Access Compliance Report

Public Rights-of-Way

(Curb Ramps)

| Intersection ID: 47310 | Main Street: WEAKLY_CT | Cross Street: FOWLER_SPRINGS_LN | Location: NW |

| ADA ID: C182C8BC91B8 | Ramp Type: BlendTrans1 | Initial Pass/Fail: Fail | Overall Compliance: No |

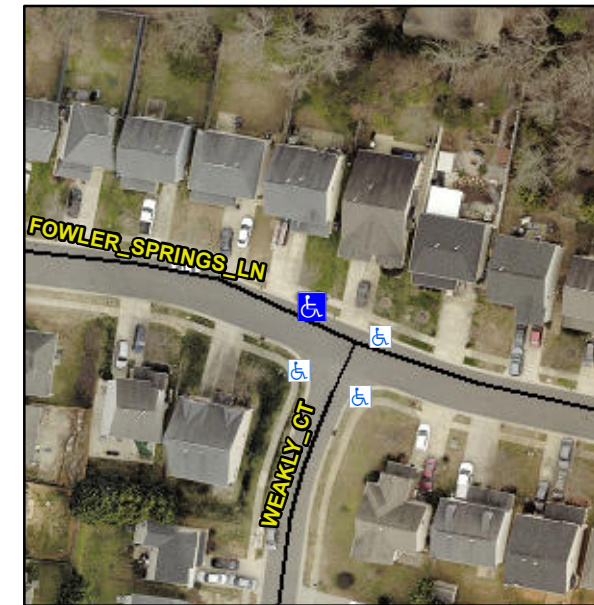
Not Found, R304.5.1, R304.5.3

| Compliance | Description | Data | Compliance | Description | Data |
|------------|-----------------------|-------|------------|-----------------------------|------|
| No | Ramp Width (in) | 47.0 | No | BlendTrans XSlope (%) | 5.8 |
| | | | No | Curb Slope (%) | 11.1 |

Remove & Replace Curb Ramp With Two New Directional Ramps or Equivalent.
